- 6. Scholz-Rediske Subdivision; KPB File : 2024-107  
Seabright Surveying / Scholz, Rediske  
Location: Ohlson Mountain Road & John Lee Avenue  
Diamond Ridge Area / Kachemak Bay APC**

**ITEM #6 - PRELIMINARY PLAT  
SCHOLZ-REDISKA SUBDIVISION**

<b>KPB File No.</b>	2024-107
<b>Plat Committee Meeting:</b>	October 28, 2024
<b>Applicant / Owner:</b>	Tadhg Bernard Scholz & Tyroan James Rediske
<b>Surveyor:</b>	Katherine Kirsis/ Seabright Survey & Design
<b>General Location:</b>	Ohlson Mountain North of Homer/ Kachemak APC

**STAFF REPORT**

**SCHOLZ-REDISKE SUBDIVISION**  
A SUBDIVISION OF THE SE1/4 SE1/4 SE1/4 & E1/2 W1/2 NE1/4 SE1/4 LYING SOUTH OF OHLSON MTN ROAD SEC. 29, T. 5 S., R. 15 W., SEWARD MERIDIAN, KENAI PENINSULA BOROUGH, THIRD JUDICIAL DISTRICT, ALASKA  
CONTAINING 11.37 ACRES

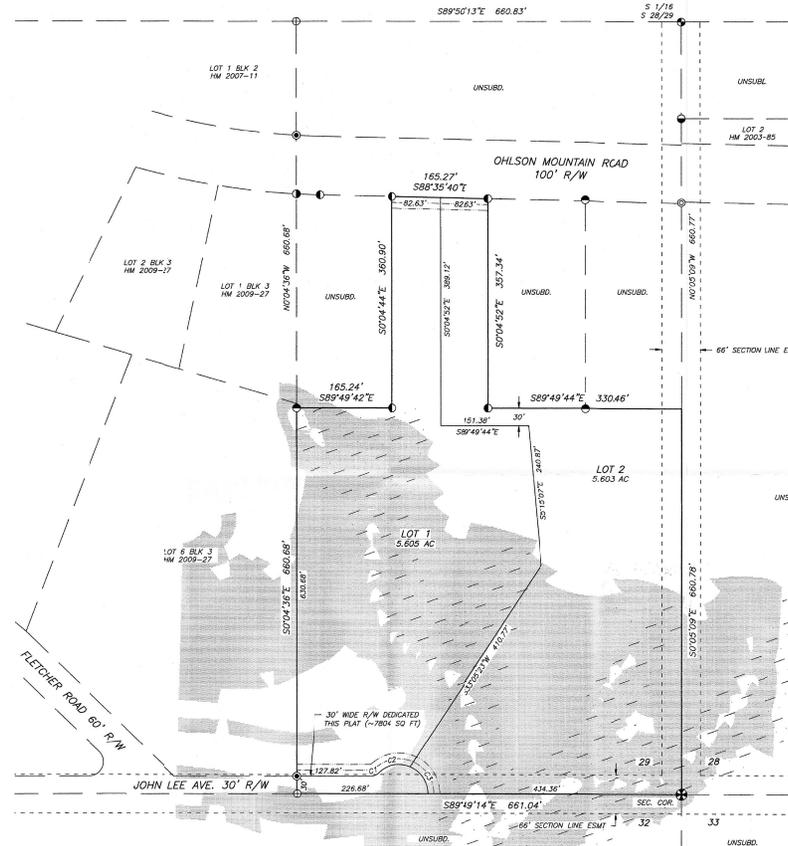
through the subdivision following the white spots in the northwest corner of lot 1 to the south line of lot 2 east of John Lee Ave. The steep slopes run towards the drainway; **staff recommends** the surveyor add arrows to indicate direction of the slopes from high to low.

The are wetlands on the plat indicated by the cross hatch markings in the middle of the drawing. The wetland is of type riverine according to the KWF Wetlands Assessment. The marking should remain on the drawing for the final submittal. Correct wetland notice is on the drawing at plat note #5 and should remain on the final submittal.

There is a utility easement listed in the plat notes at #8. Upon reading the easement, it does contain a legal description that does not cross this plat boundary. Staff recommends the surveyor remove the plat and notify the title company of the issue. the location of the utility line can be scene on aerial photos to the west, running in a southwest / northeast direction.

Revise the KPB File NO to 2024-107

Add aka Tadhg Scholz to Tadhg Bernard Scholz name.

Change the mailing address of Tyroan James Rediske to PO Box 2662, to match Assessing data.

Connection of right-of-way of Ohlson Mountain Road to east on the north point looks offset, please check and adjust as needed.

Add labels for Mossberg Dr and Easterday Rd to the vicinity map.

Match the wording of the Certificate of Acceptance to that as shown in KPB 20.60.190(7).
